Access Compliance Report

Public Rights-of-Way

(Curb Ramps)

Intersection ID: 51074	Main Street: HEATHCOTT_CR	Cross Street: SILVER_GLEN_LN	Location: SE
ADA ID: 4C318C45C495	Ramp Type: PerpDiag	Initial Pass/Fail: Fail	Overall Compliance: No
Codes/Mitigation Info/Possible Solution			Severity Score: 35
			Field Measurements/Component Compliance

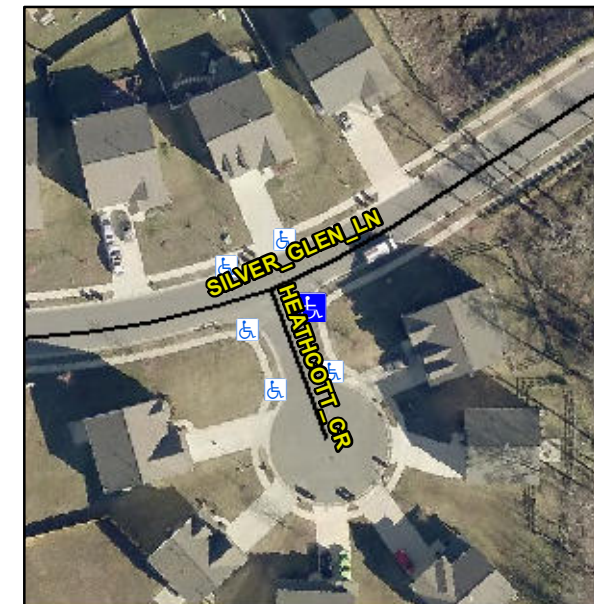
Not Found, R304.5.1, R304.2.2, R304.5.3

Compliance	Description	Data	Compliance	Description	Data
N/A	Ramp Length (in)	52.0	No	Ramp Slope (%)	15.6
No	Ramp Width (in)	47.5	No	Ramp XSlope (%)	3.7
N/A	Flare Type LT	N/A	N/A	Flare Type RT	N/A
N/A	Flare Slope LT (%)	N/A	N/A	Flare Slope RT (%)	N/A
N/A	Flare Traversable LT?	N/A	N/A	Flare Traversable RT?	N/A
N/A	Landing Length (in)	N/A	N/A	DWS Provided?	N/A
N/A	Landing Width (in)	N/A	N/A	DWS Contrast?	N/A
N/A	Landing Slope (%)	N/A	N/A	DWS Length (in)	N/A
N/A	Landing X Slope (%)	N/A	N/A	DWS Full Width?	N/A
N/A	Landing Curb? (Y/N)	N/A	N/A	DWS Offset (in)	N/A
N/A	Shared Landing?	N/A			
N/A	Gutter Ponding?	N/A	N/A	Gutter Slope (%)	N/A
N/A	Gutter Lip Ht (in)	1.0	N/A	Gutter X Slope (%)	N/A
N/A	Painted X Walk1?	No	N/A	Painted X Walk2?	No
	X Walk 1 Direction	To N		X Walk 2 Direction	To W
N/A	X Walk 1 Width (in)	N/A	N/A	X Walk 2 Width (in)	N/A
	X Walk 1 Slope (%)	1.7		X Walk 2 Slope (%)	3.1
	X Walk 1 X Slope (%)	3.3		X Walk 2 X Slope (%)	1.1

Remove & Replace Curb Ramp With Two New Directional Ramps or Equivalent.
